<b>AGENDA SECTION:</b> PUBLIC HEARINGS	<b>ORIGINATING DEPT:</b> PLANNING	<b>ITEM NO.</b> <span style="font-size: 1.5em; font-family: cursive;">E-6</span>
<b>ITEM DESCRIPTION:</b> Land Subdivision Permit (preliminary plat) #03-03 by Century Point LLC to be known as Century Point First. The applicant is proposing to subdivide approximately 10.57 acres of land into 34 lots for single family residential development. The Plat also proposes to dedicate right-of-way for new public roadways, including Century Hills Drive and two cul-de-sac roads. The property is located along the east side of East Circle Drive (CR22), north of Silver Creek Road at the East Circle Drive entrance to the Century Hills development.		<b>PREPARED BY:</b> Brent Svenby, Planner

PRELIMINARY PLAT

**RE: Land Subdivision Permit (preliminary plat) #03-03 by Century Point LLC to be known as Century Point First. The applicant is proposing to subdivide approximately 10.57 acres of land into 34 lots for single family residential development. The Plat also proposes to dedicate right-of-way for new public roadways, including Century Hills Drive and two cul-de-sac roads. The property is located along the east side of East C

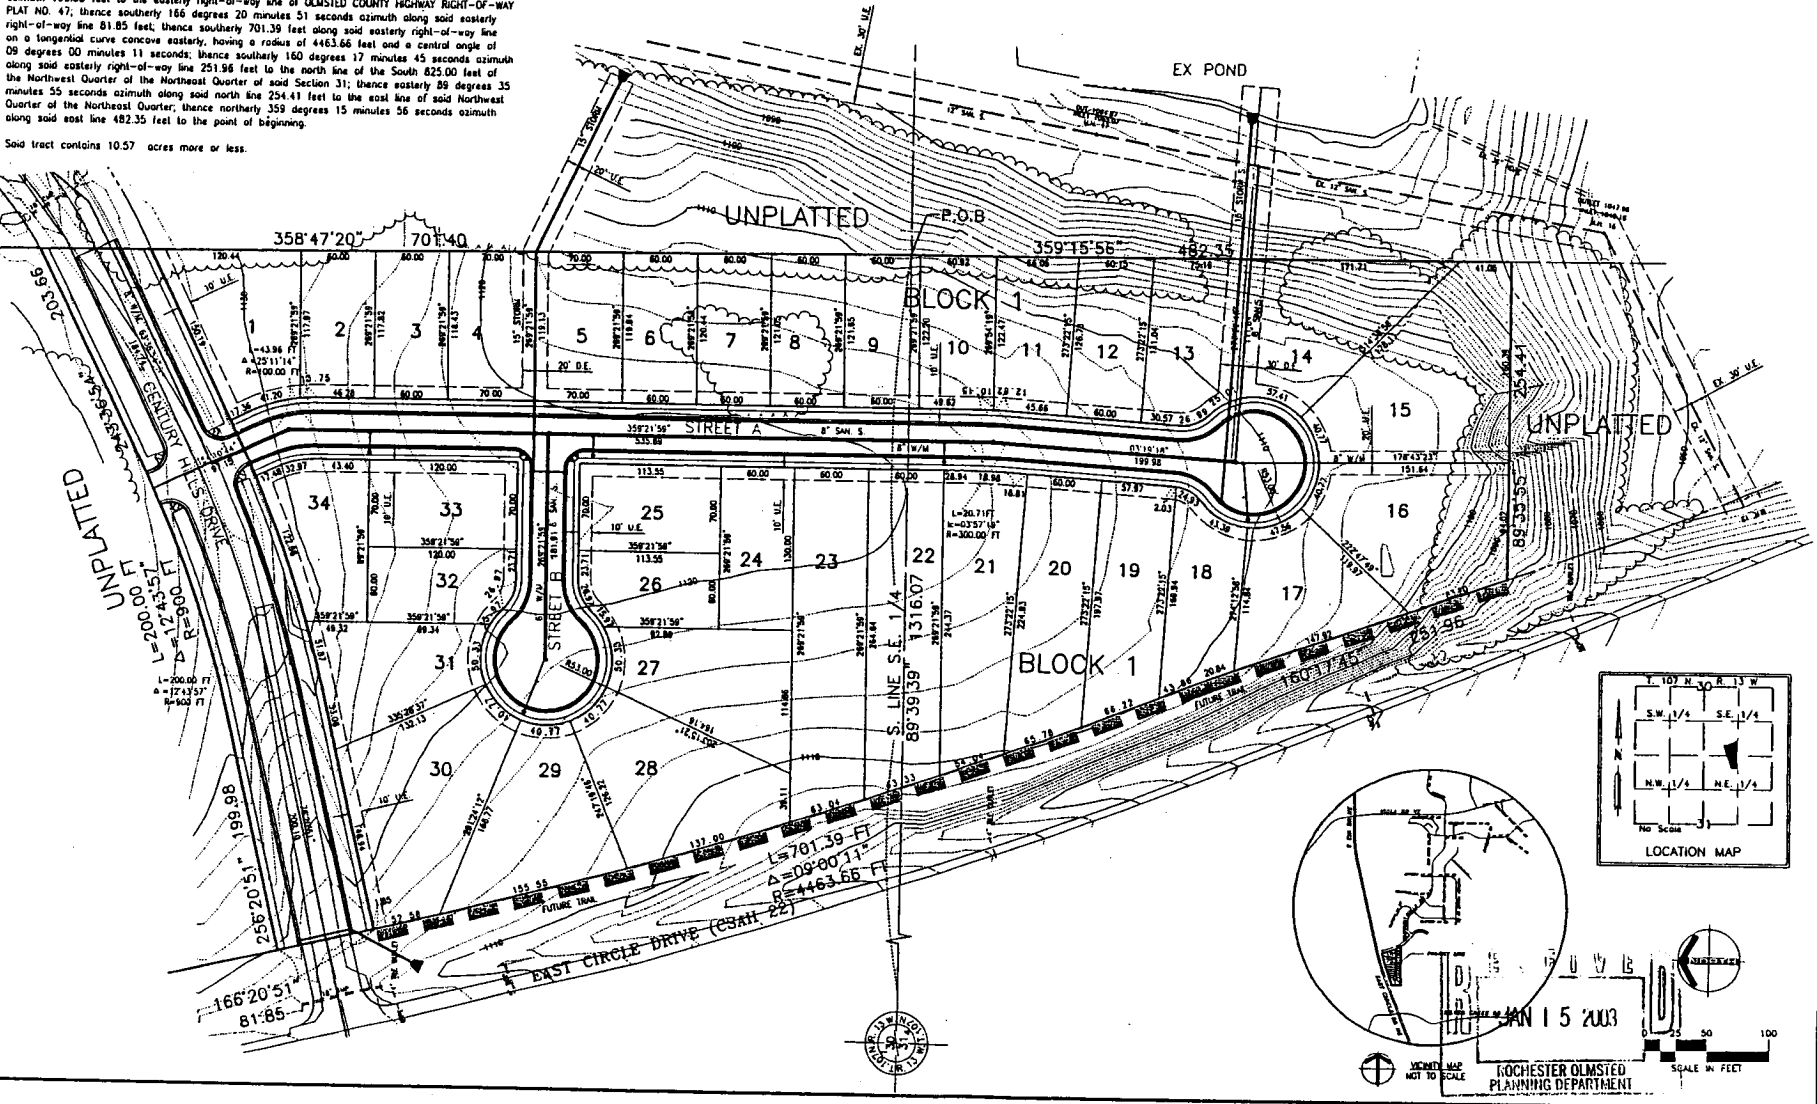
The use of Century Hills Drive is incorrect based on the GDP for Century Hills. The name of the roadway will need to be changed. Roadways are not named at this time. Names will need to be approved by the Planning Department Addressing Staff prior to final plat application.

Controlled access will be required along the entire frontage of East Circle Drive and Century Hills Drive NE, with the exception of the proposed public street access.

This area is too low in elevation to be served directly from the North East High Level Water System, as static water pressures would be over 100 PSI. A public pressure reducing station will be required, which would lower the pressure in this area to within an allowable range (anticipated low to upper 50's PSI). This station would also need to be sized to be able to serve the adjacent property to the south.

- ***Access control shall be shown along CSAH 22.***
- ***Any proposed work in CSAH 22 right of way requires an Olmsted County Highway Permit.***

1. Reference to illustrated roadway EAST CIRCLE DRIVE (C.S.A.H. 22) is incomplete.

2. The use of Century Hills Drive is incorrect according to my interpretation of the GDP and the Revised GDP. The existing Century Hills Drive NE would end at the intersection created just NE of this plat.

3. The two cul-de-sacs in the plat need to be designated also.

Cul-de-sacs less than 96 feet in diameter shall be marked "No Parking" along the cul-de-sac. The cul-de-sacs associated with this plan are indicated as less than 96 feet and therefore shall be marked "No Parking".

Streets less than 36 feet in width shall be posted "No Parking" along one side of the street. Streets less than 28 feet in width shall be posted "No Parking" along both sides of the street. The streets associated with this plan are indicated as less than 28 feet and will require "No Parking" along both sides of the street.

1. **The Final Plat shall include:**
  - **controlled access shall be dedicated along the entire frontage of East Circle Drive and along the east/west roadway serving the Century Hills Development with the exception of the two proposed roadways shown on the GDP.**
  - **Roadway names approved by the Planning Department Addressing Division.**

4. The applicant shall provide a public pressure reducing station, which will lower the pressure in this area to within an allowable range (anticipated low to upper 50's PSI). This station shall be sized to serve the adjacent property to the south.

8. No parking shall be allowed, at any time, along the cul-de-sacs associated with this plat, along both sides of each roadway associated with this plat and along both sides of Century Hills Drive NE and shall be posted "No Parking".

**RECOMMENDATION:** Add the directional to roadway name. **EAST CIRCLE DRIVE NE (C.S.A.H.#22).**

**RECOMMENDATION:** This roadway needs to be given a new designation.

**RECOMMENDATION:** Name both of these roadways, and use the roadway type LANE and directional of NE.
